NOTICE OF DECISION
MYRTLEWOOD SUBDIVISION TENTATIVE PLAN – SUB221-0002

December 9, 2021

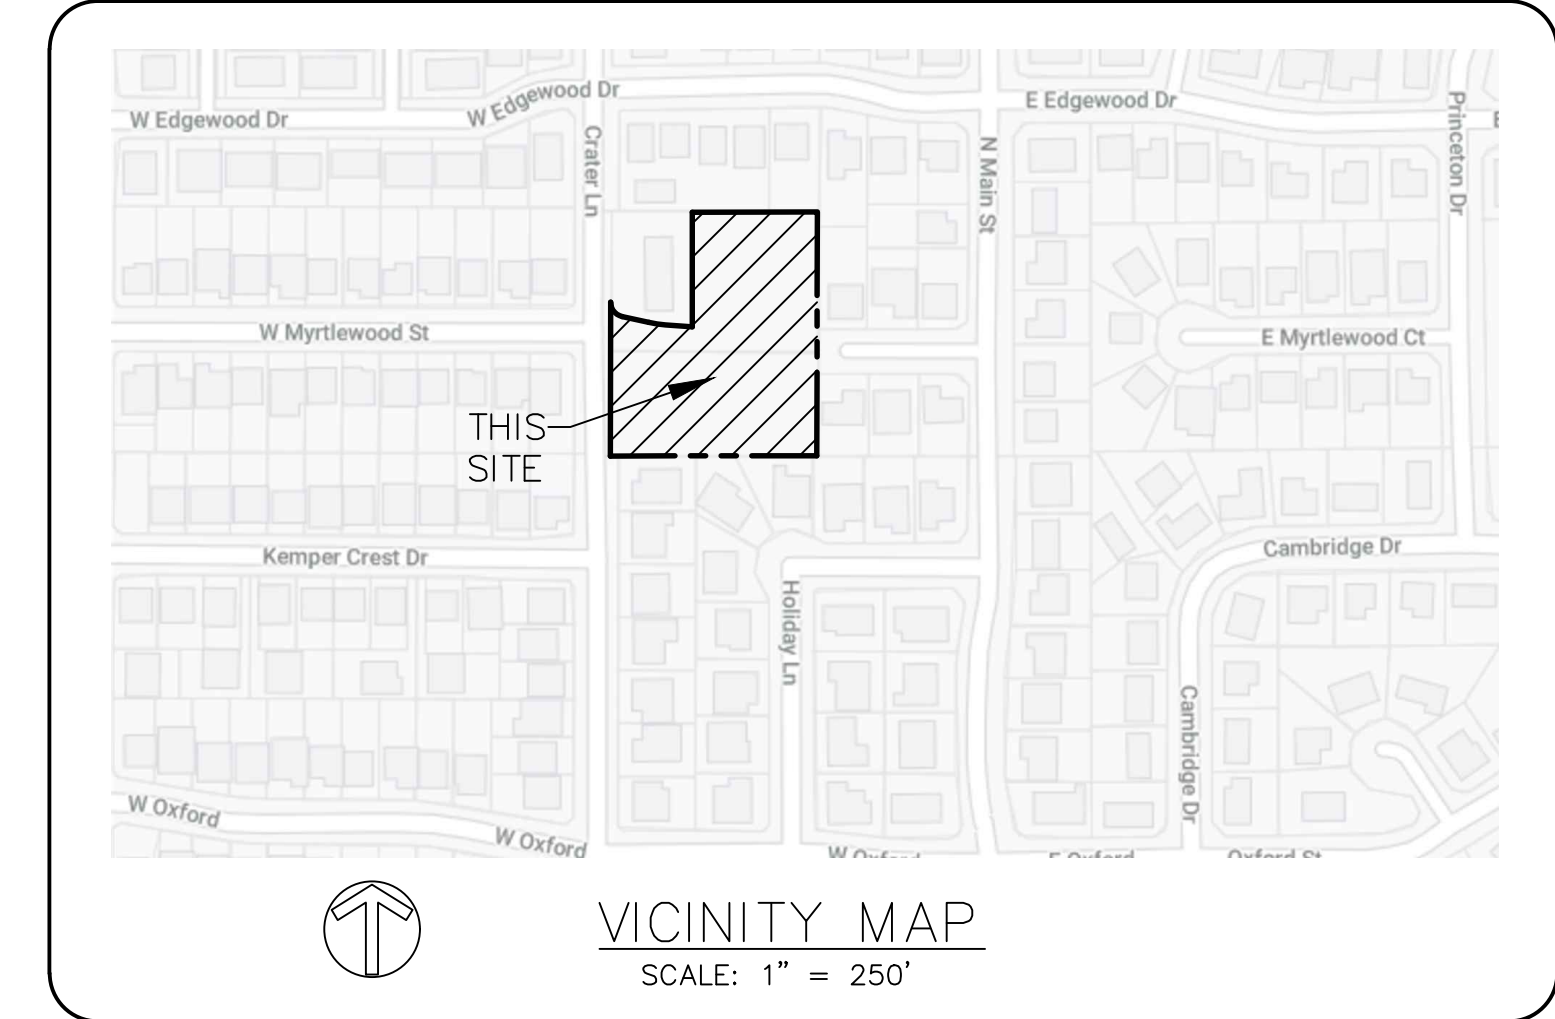
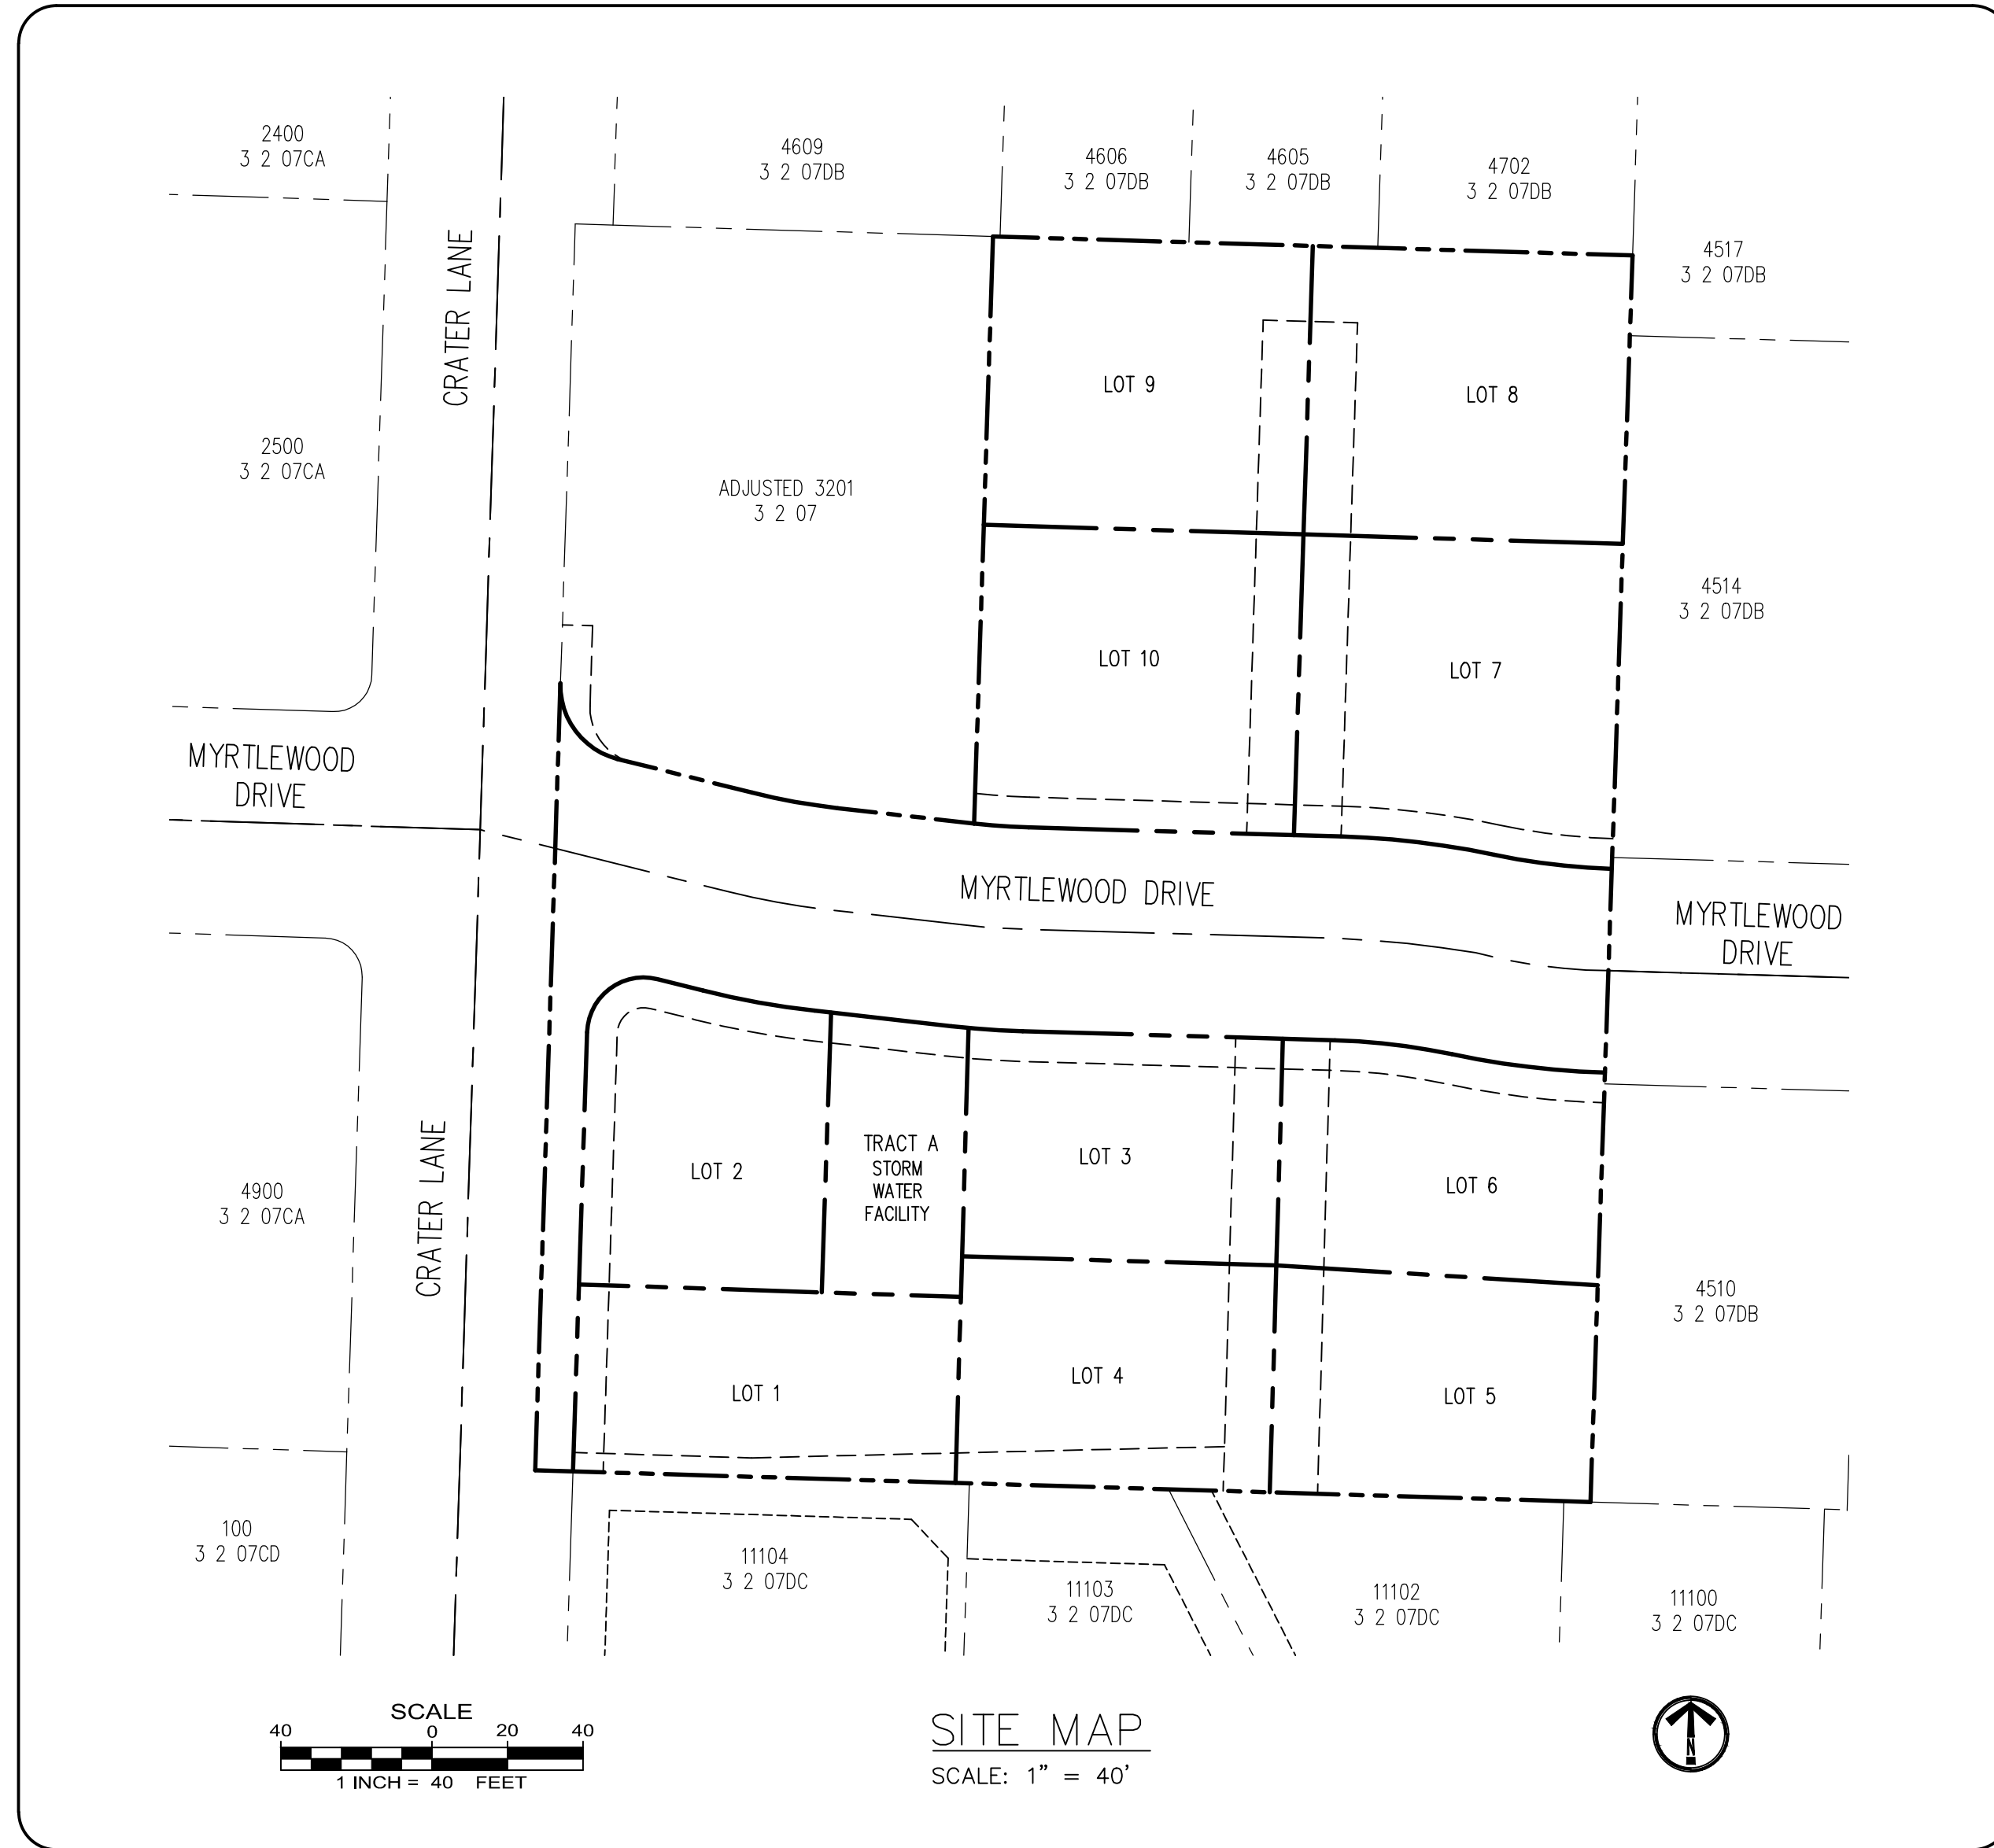
RESPONSE: All proposed improvements have been designed to meet the development standards of the Newberg Public Works Design and Construction Standards. Upon gaining land use approval for the proposed subdivision, the Applicant will be submitting detailed civil plans to the City's Public Works department for their review and approval to assure all public improvements are designed, constructed, and maintained in compliance with the City's public works design and construction standards.
